EXTRACTS FROM ARCHITECTS' REPORT AND DRAWINGS FOR DA PLN-22-790 – MELVILLE STREET PEDESTRIAN BRIDGE

LEVEL 1 (LOWER LEVEL) - LANEWAY + BRIDGE PLAN

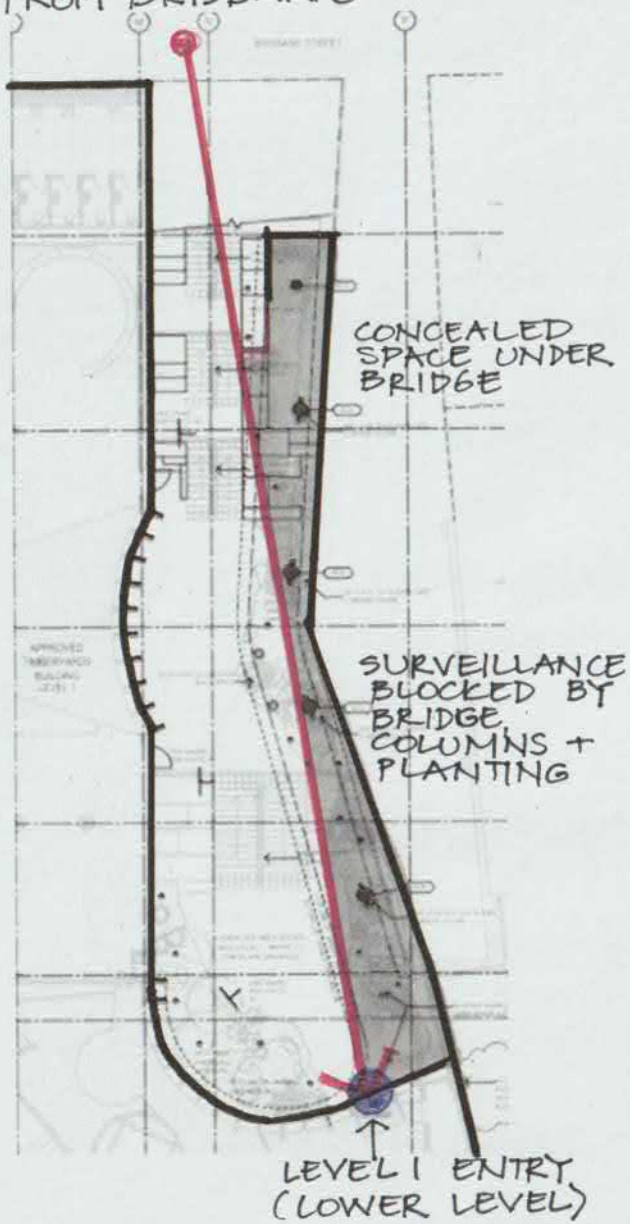
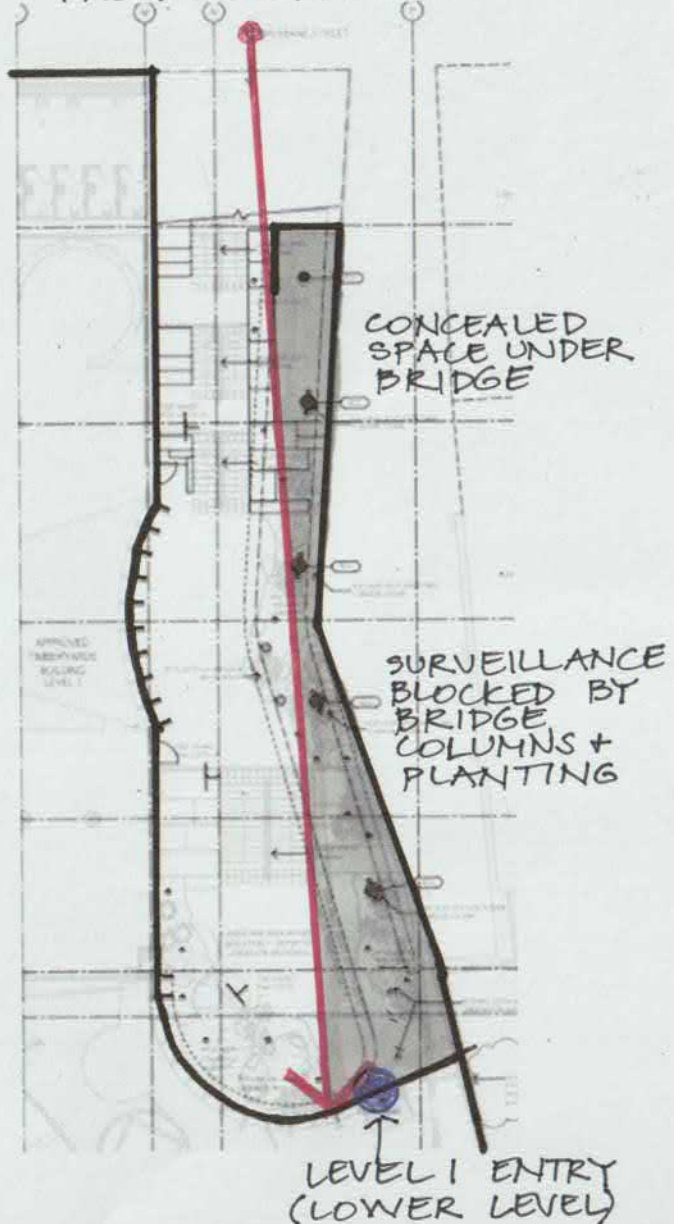
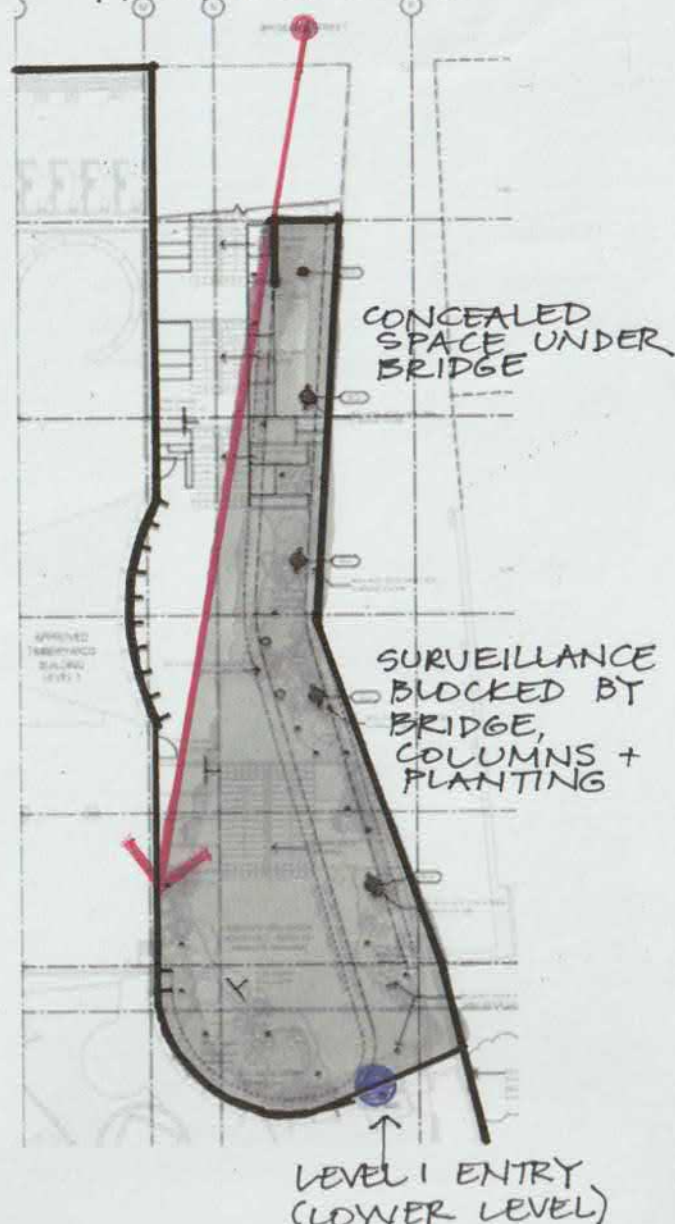
■ AREAS WHERE PASSIVE SURVEILLANCE FROM BRISBANE ST BLOCKED

LEVEL 2 (UPPER LEVEL) - LANEWAY + BRIDGE PLAN

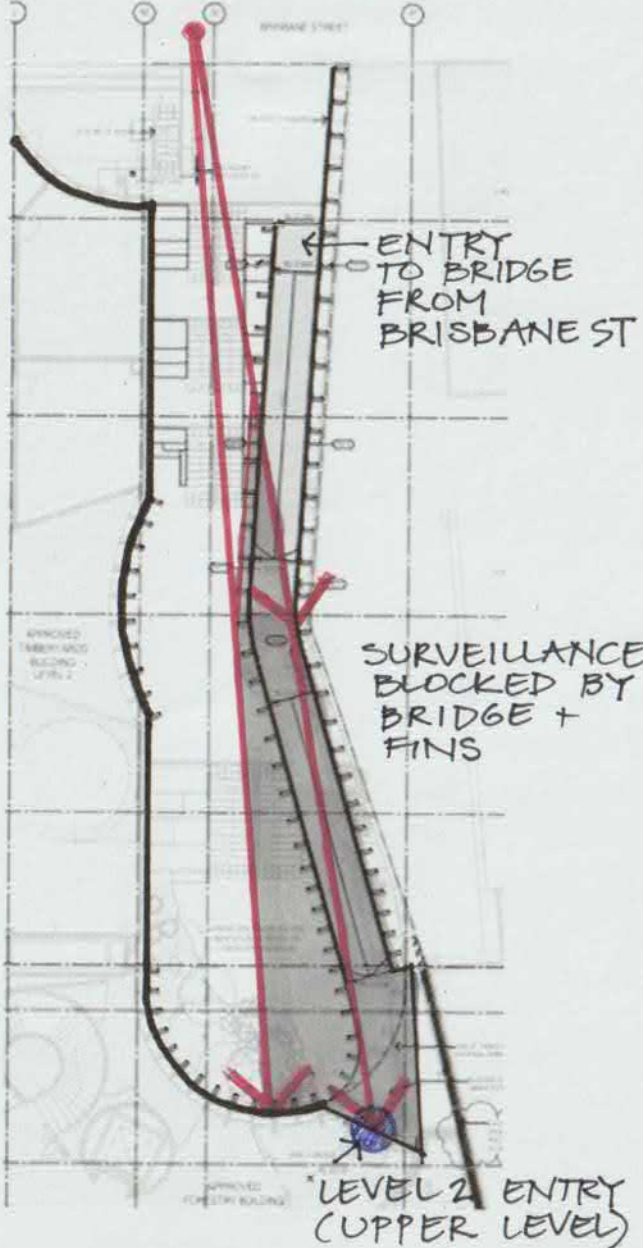
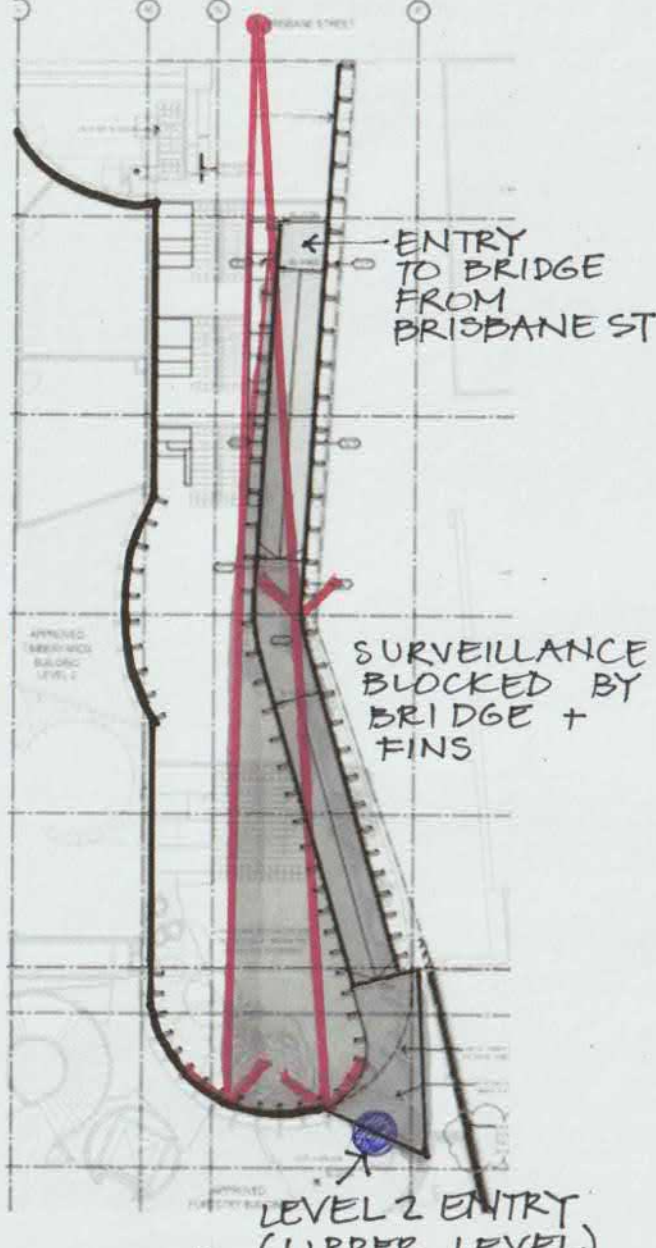
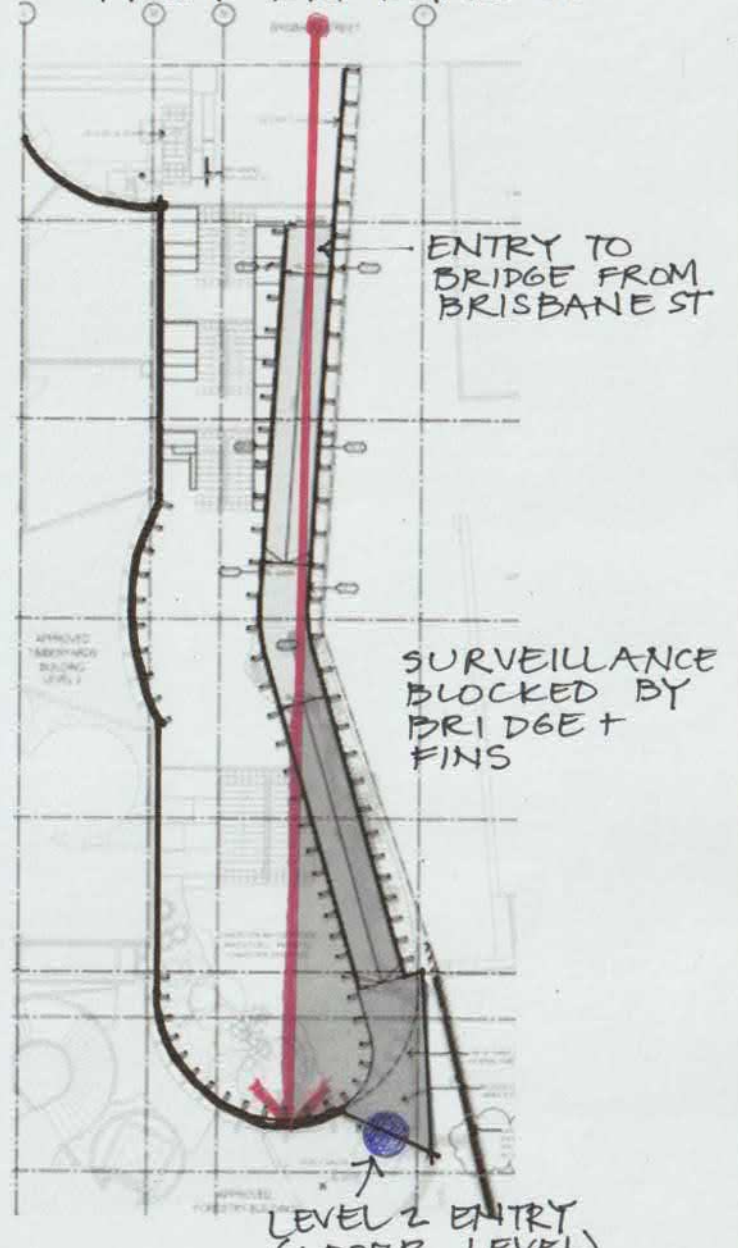
■ AREAS WHERE PASSIVE SURVEILLANCE FROM BRISBANE ST BLOCKED

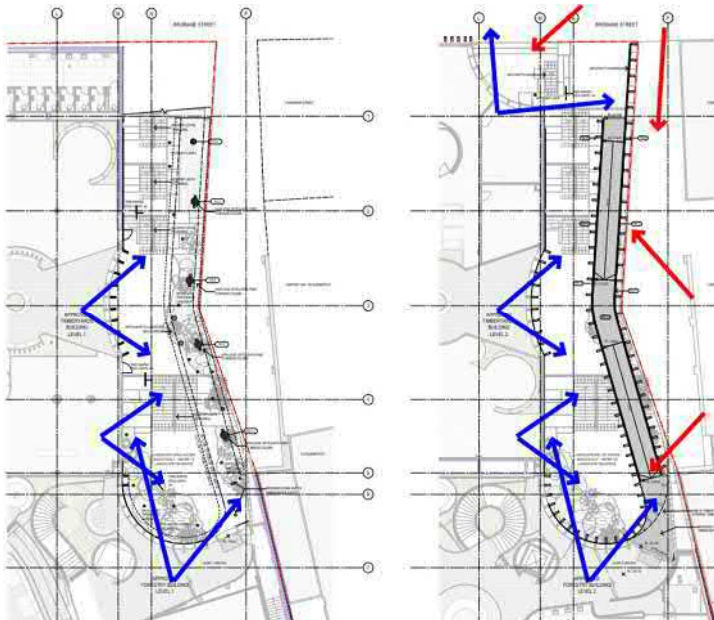
EXAMPLE OF "SELECTIVE" CHOICE OF VIEWS, NONE OF WHICH SHOW ACTUAL SIGHT LINES FROM BRISBANE STREET, OR THE PROBLEMS WITH PASSIVE SURVEILLANCE

INDICATIVE SIGHT LINES FROM THE ARCHITECTS' REPORT NONE OF WHICH LOOK DOWN THE LANEWAY AND BRIDGE FROM BRISBANE STREET. THESE APPEAR TO HAVE BEEN CHOSEN SO THAT THE PROBLEMS WITH PASSIVE SURVEILLANCE AND CONCEALED SPACES ARE NOT IDENTIFIED AND ONLY ADDRESS OVERLOOKING FROM ADJACENT BUILDINGS.

THEY DO NOT ADDRESS CLAUSES 22.4.4.A1 (a) and (d) OF THE HOBART INTERIM PLANNING SCHEME 2015.

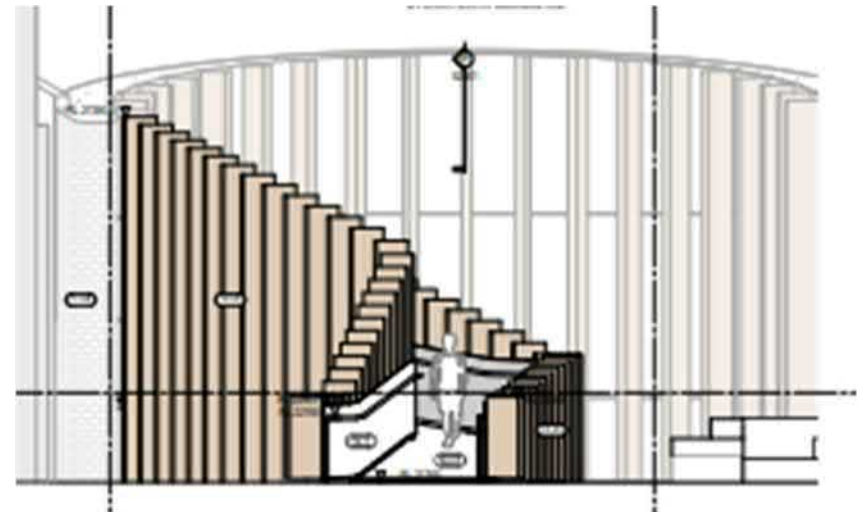
ELEVATION FROM BRISBANE STREET FROM THE ARCHITECTS' DRAWINGS WHICH CLEARLY SHOWS THAT THERE IS A LACK OF PASSIVE SURVEILLANCE OF THE UPPER AND LOWER ENTRIES AND OF AREAS UNDER THE PEDESTRIAN BRIDGE.
